ELECTRICAL WIRING	
SCALE:	APPROVED BY:
DATE: 5-5-06	DRAWN BY:
R.V. CUSTOM PRODUCTS, INC.	
	REVERSED
DRAWING NUMBER	
Pg 15

Attn: All Fleetwood Parts & Service

CB-115 REV ϕ is a replacement for RV Custom Products PC boards

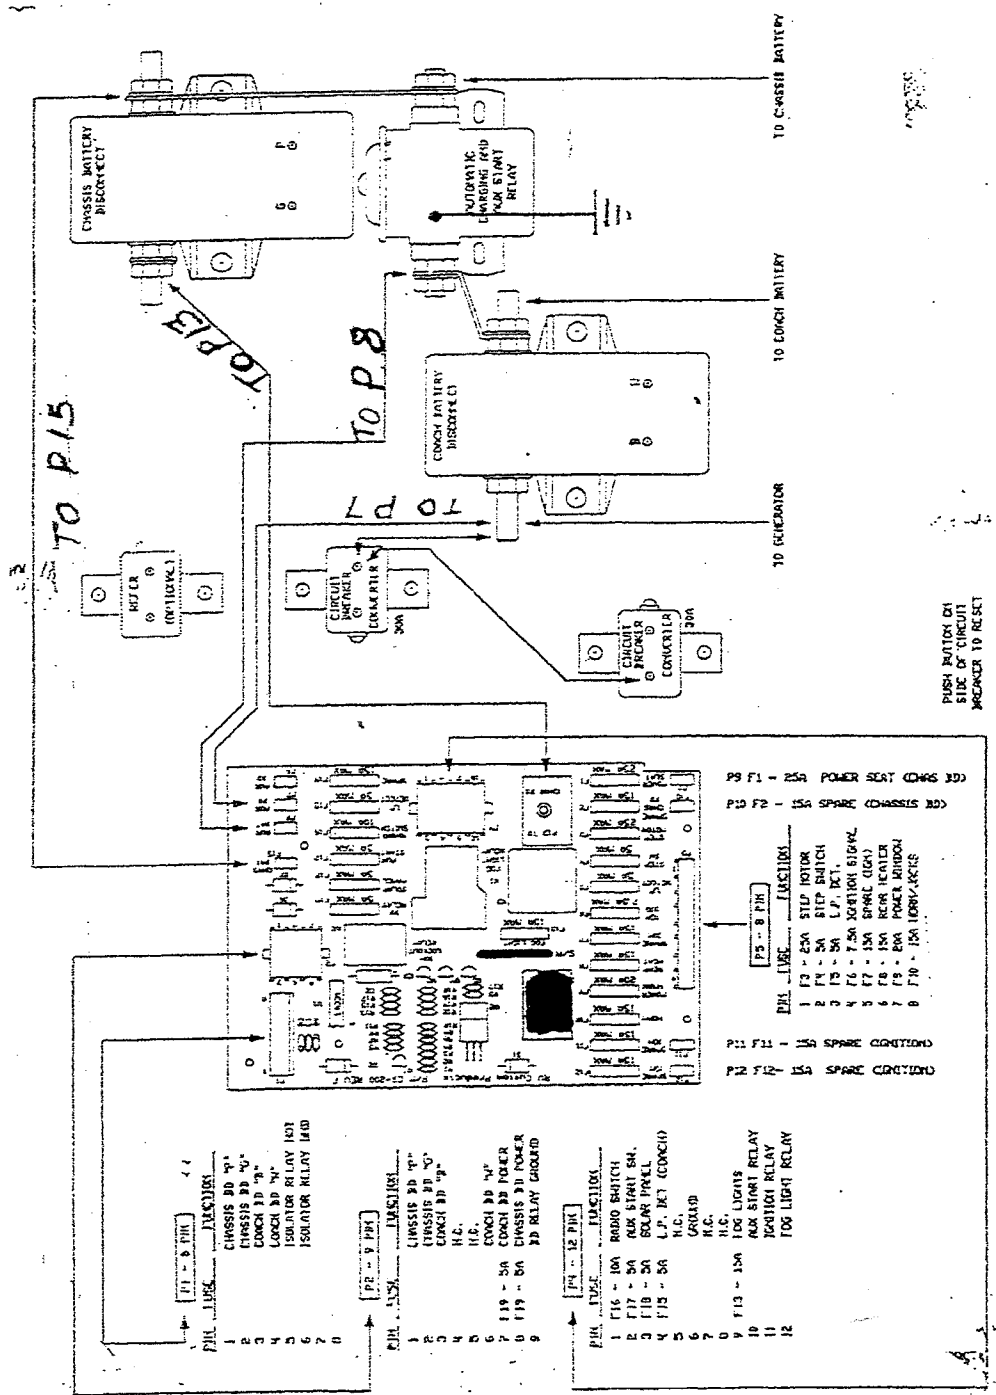
CB-200 Rev A thur ϕ . CB-115 REV ϕ has circuit board mounted

ignition relay. When installing REV ϕ board it is unnecessary to

connect the ignition relay mounted in breaker box.

do not remove relay and the orange wire is no longer needed.

Connect one black wire of AUX start relay to breaker box.

ATTN: ALL FLEETWOOD PARTS & SERVICE

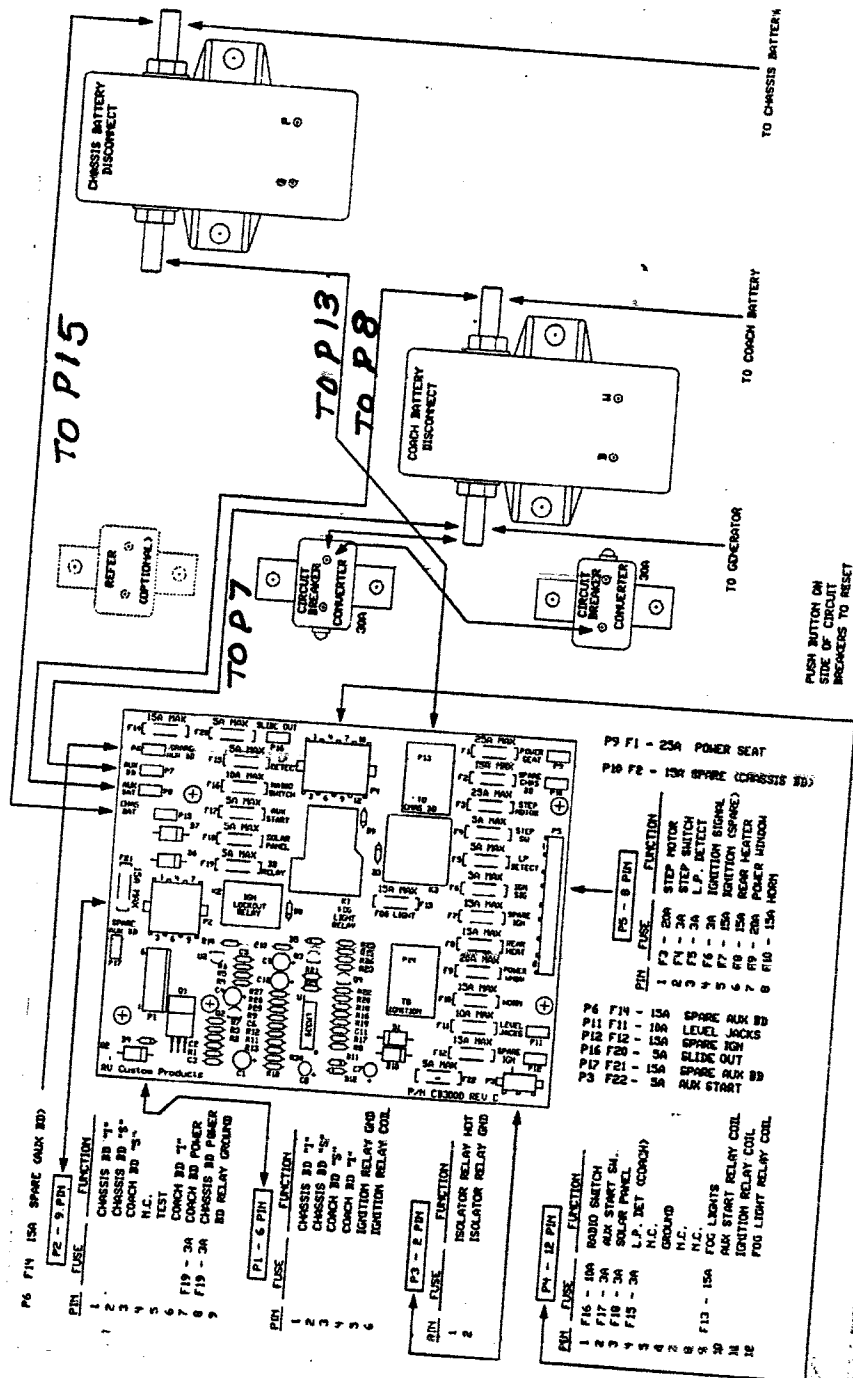
CB-300 REV. F IS A REPLACEMENT FOR RV CUSTOM PRODUCTS PC BOARDS REV. A, B, C, D, & E. & F. *G H J K L N*
 CB-300 REV. P HAS CIRCUIT BOARD MOUNTED IGNITION RELAY. WHEN INSTALLING REV. P BOARD IT IS UNNECESSARY TO CONNECT THE IGNITION RELAY MOUNTED IN BREAKER BOX.
 SHORT BLACK WIRE IS GROUND AND SHOULD BE ATTACHED TO BREAKER BOX.
